SUBJECT: Limerick Generating Station, Unit 1  
 Technical Specifications Change Request No. 90-01-1

TECHNICAL SPECIFICATIONS CHANGE REQUEST

No. 90-01-1

"Proposed Changes to the Technical Specifications to  
Replace the Hydraulic Control Unit (HCU) Isolation Boundaries"

FIGURE 1

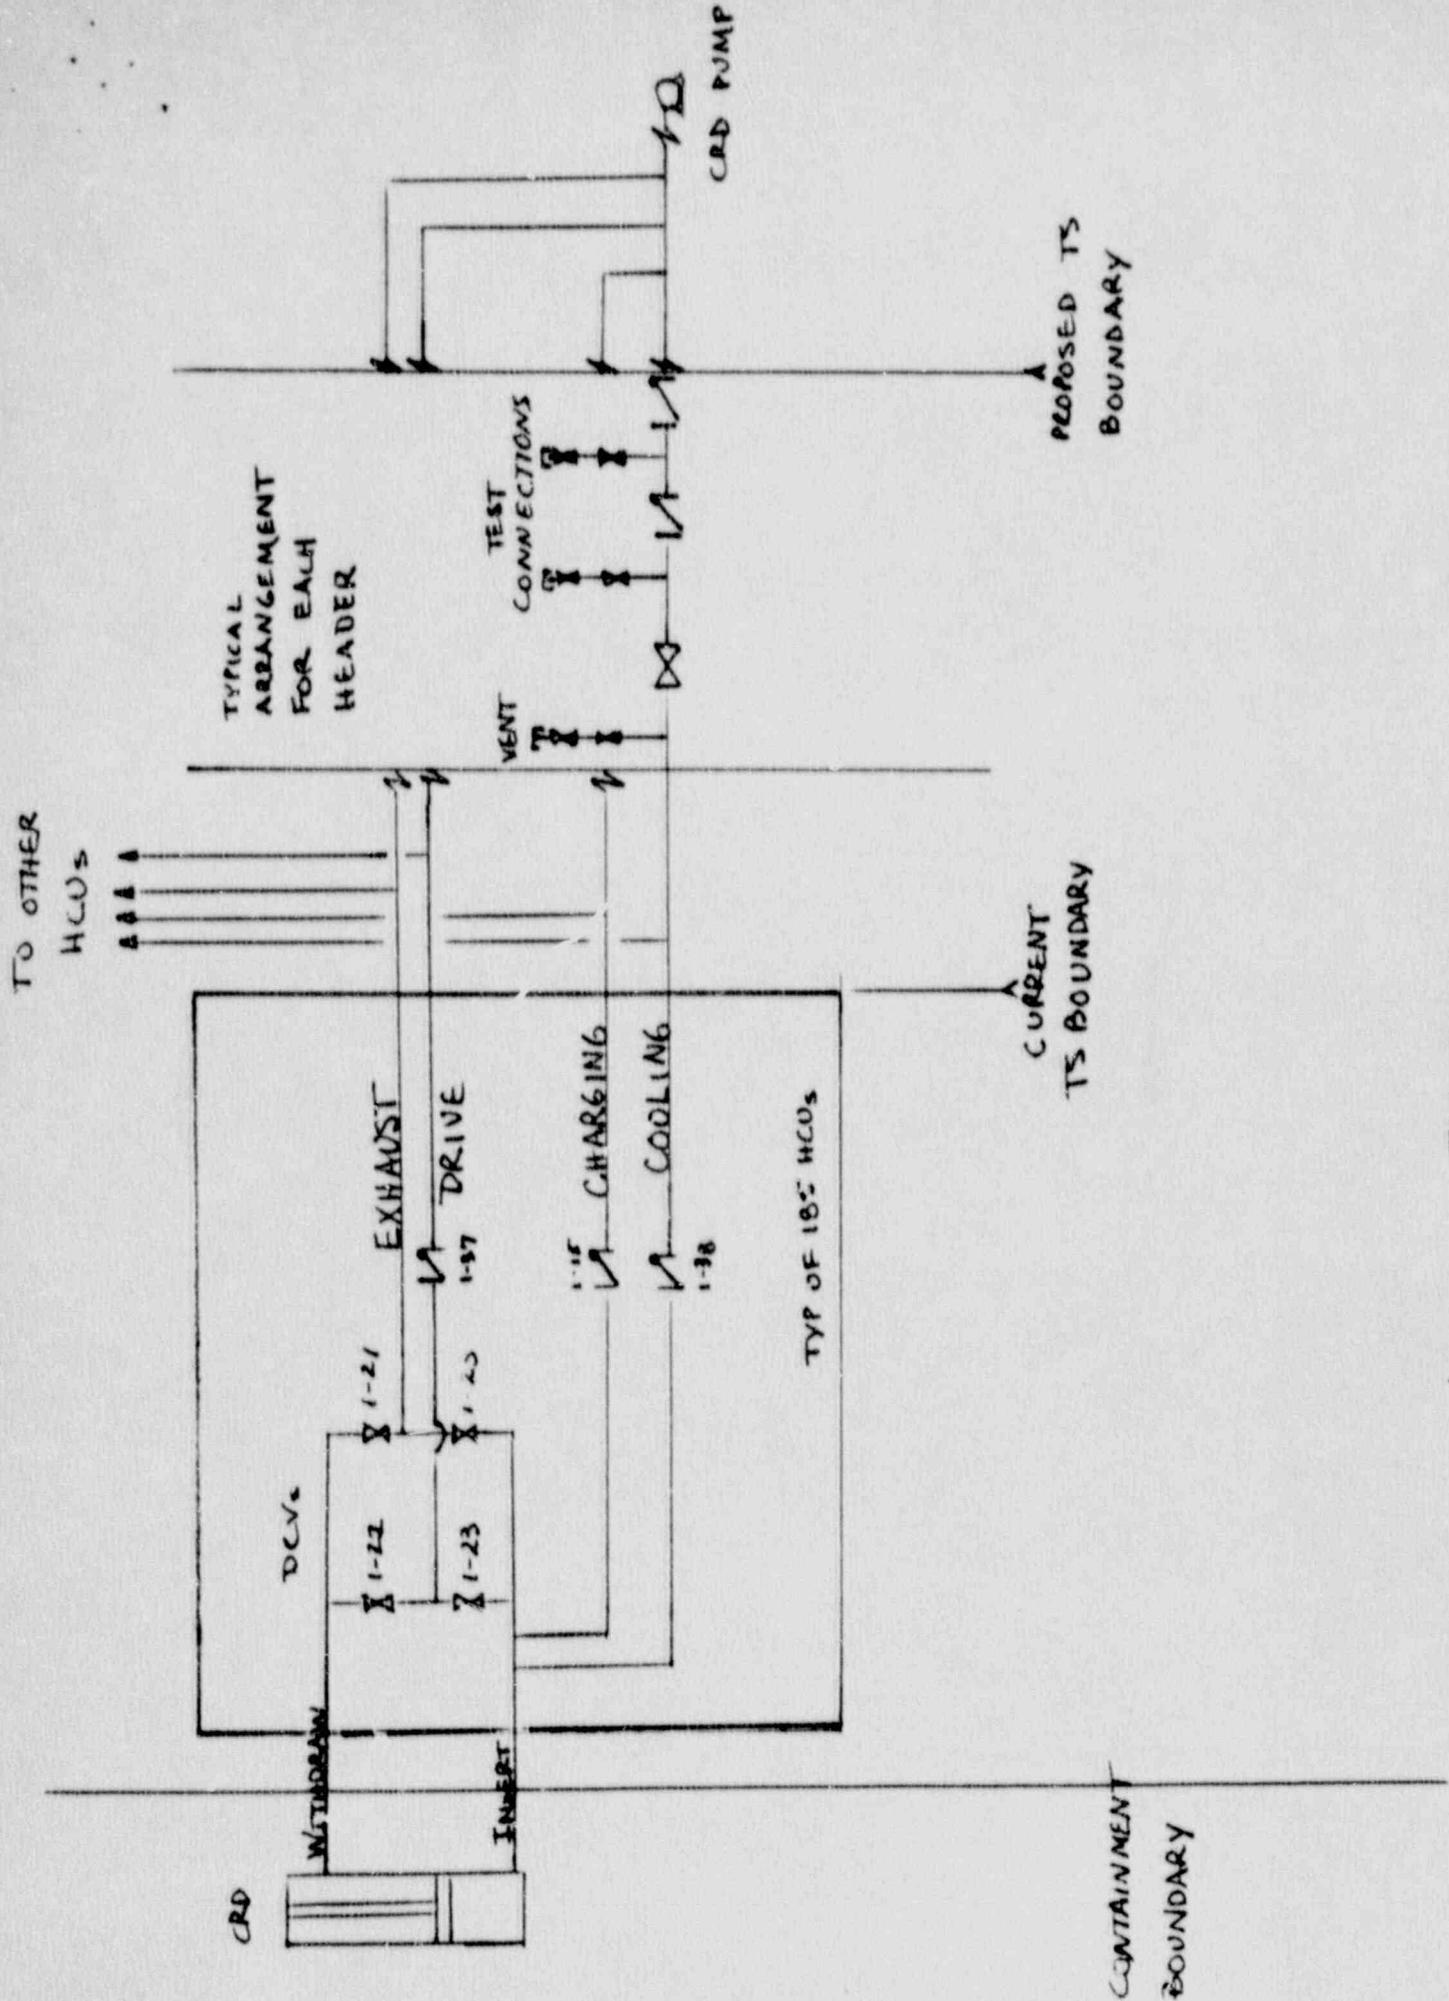
To minimize critical path outage time, new check valves will be installed in the CRD supply headers in four locations, effectively extending the isolation boundary from the HCUs to these new valves (See Figure 1). These four (4) new valves will reduce the number of testable CRD penetrations from approximately 1300 to four.

The proposed TS change will take credit for the new check valves installed in each of the CRD headers to the HCUs (drive, cooling, charging, exhaust) between the main control station and the vent valve. These valves constitute a new isolation boundary. Each check valve station consists of two check valves, a block valve and two test connections. This enables each check valve to be tested individually instead of during the critical path ILRT. Each check valve station is accessible from an existing platform near the existing vent valves.
